Access Compliance Report Public Rights-of-Way (Curb Ramps)

Main Street: WHEELER_PL Cross Street: WHITNEY_DR Location: NE

ADA ID: RPAT211001112413 Ramp Type: Type 1 - Perpendicular Diagonal Initial Pass/Fail: Pass Overall Compliance: No Severity Score: 25

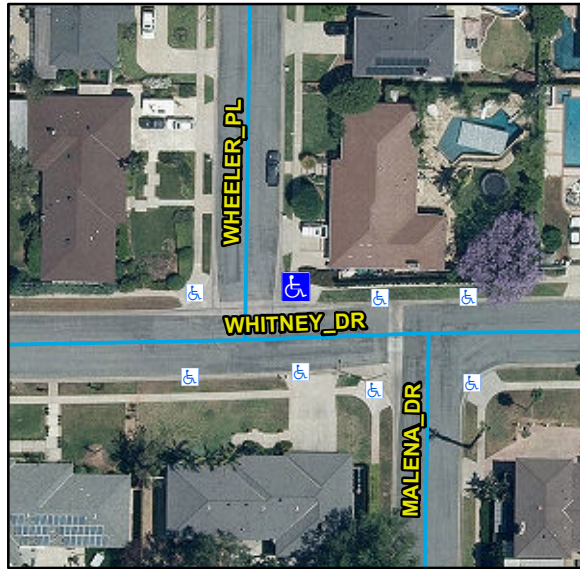
Compliance	Description	Data	Compliance	Description	Data
N/A	Ramp Length (in)	119	N/A	Flare Type LT	
Yes	Ramp Width (in)	50			Sloped
Yes	Ramp Run Slope (%)	5.8	N/A	Flare Slope LT (%)	8.2
Yes	Ramp Cross Slope (%)	3.8	N/A	Flare Traversable LT	No
N/A	Landing Present	No	N/A	Flare Type RT	
N/A	Landing Length (in)	N/A			Sloped
No	Landing Width (in)	N/A	N/A	Flare Slope RT (%)	4.6
No	Landing Run Slope (%)	N/A	N/A	Flare Traversable RT	No
No	Landing Cross Slope (%)	N/A	No	DWS Provided	No
N/A	Landing Movement Obstructed?	Yes	N/A	DWS Contrast	N/A
	Landing Movement Type	Bushes	N/A	DWS Length (in)	N/A
N/A	Landing Shared	N/A	N/A	DWS Full Width	N/A
N/A	Clear Space	Yes	N/A	DWS Offset Left (in)	N/A
N/A	Clear Space To Crosswalk (in)	48	N/A	DWS Offset Right (in)	N/A
N/A	Marked Crosswalk 1	No	N/A	Marked Crosswalk 2	No
	Crossing 1 Direction	W		Crossing 2 Direction	S
	Marked Crosswalk 1 Width (in)	N/A		Marked Crosswalk 2 Width (in)	N/A

N/A	Ramp Inside Crosswalk 1	N/A	Yes	Ramp Inside Crosswalk 2	N/A
	Crossing 1 Slope (%)	3		Crossing 2 Slope (%)	4.3
	Crossing 1 Cross Slope (%)	6.5		Crossing 2 Cross Slope (%)	0.8
Yes	Gutter Ponding	No	No	Curb Slope	10.8
Yes	Gutter Lip Height (in)	0		Road Run Slope (%)	5.9
No	Gutter Run Slope (%)	5.2		Road Cross Slope (%)	7.5
Yes	Gutter Cross Slope (%)	4.4			
Yes	Overall Surface Condition: Acceptable		No	Perp Joint Present	No
	Cross Gutter Present?	Yes		Spandrel Present?	Yes
	Replace Cross Gutter?	No		Replace Spandrel?	No

Remove & Replace Curb Ramp With Two New Directional Ramps or Equivalent. Remove & Replace Gutter.
